UNITED STATES PATENT AND TRADEMARK OFFICE

10/566,014

Office Action Summary

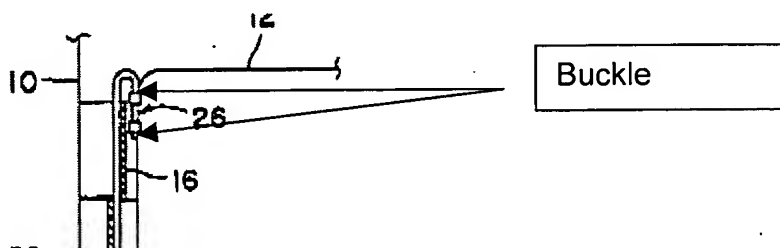
Regarding claim 1, Kirk et al. discloses a fastening system for objects (12) to be attached to an article of clothing (10) in variable positions by means of an interlocking mechanism having one ore more fastening straps (24) disposed on the object to be fastened, as well as a plurality of clothing loops (22) disposed on the article of clothing in the form of rows and columns next to and below one another. Further, a buckle (see figure below) is disposed on each fastening strap on the object to be attached below an upper fastening region.

Also, one or more pocket loops (20) are disposed on the article of clothing, in a lower region of the contact surface of the object to be attached, next to one another, in accordance with the number of fastening straps, whereby a gripper element (30), as best understood by the Examiner, provided with a hook is disposed on the free end of
